UNITED STATES PATENT AND TRADEMARK OFFICE

| APPLICATION NO. | FILING DATE | FIRST NAMED INVENTOR | ATTORNEY DOCKET NO. | CONFIRMATION NO. |
|--|-------------|----------------------|---------------------|------------------|
| 10/656,644 | 09/05/2003 | Kerry Charles Broad | PIP-PT033 | 8109 |

DETAILED ACTION

Fig. 1

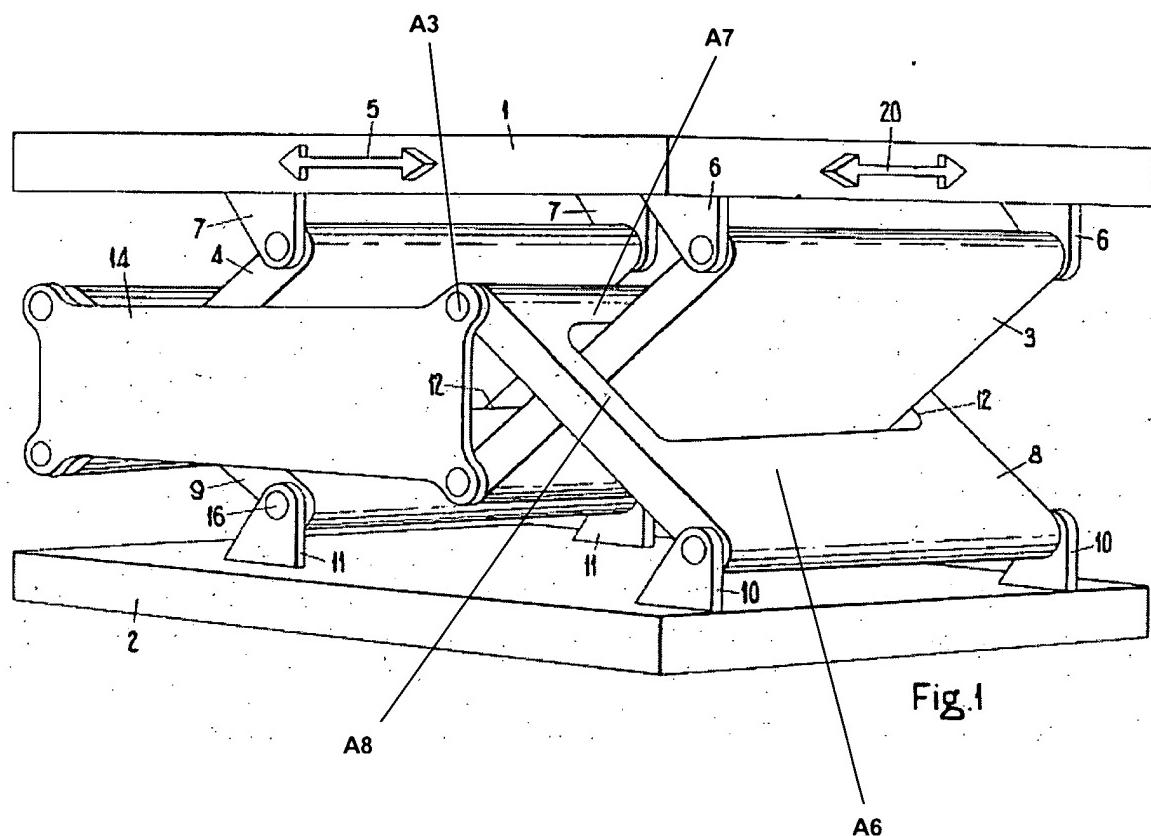
Claim 1 is rejected under 35 U.S.C. 102(b) as being anticipated by Ellis, 3,865,340 (see marked-up attachment).

Regarding claim 1, Ellis discloses, in Figure 1, a collapsible handrail mechanism including an outer stringer **14**, inner stringer **14**, a stanchion **3**, and a latching mechanism **8**. The outer stringer **14** and inner stringer **14** are jointly pivotable about a pivot point **A3**. The stanchion **3** is located between the outer stringer **14** and the inner stringer **14** and pivotally mounted to the outer stringer **14** or the inner stringer **14**. The stanchion **3** passes through the latching mechanism **8**. The outer stringer **14** or the

inner stringer **14** is pivotally mounted at the pivot point **A3**. The latching mechanism **8** has a slide plate **A6**, a top plate **A7**, and a side plate **A8**.

Applicant is reminded that in operation, the stringers will lower the stanchion from a stowed position thereby forcing the stanchion to slide on the slide plate causing the stanchion to pivot about its mounting up into an operation position.
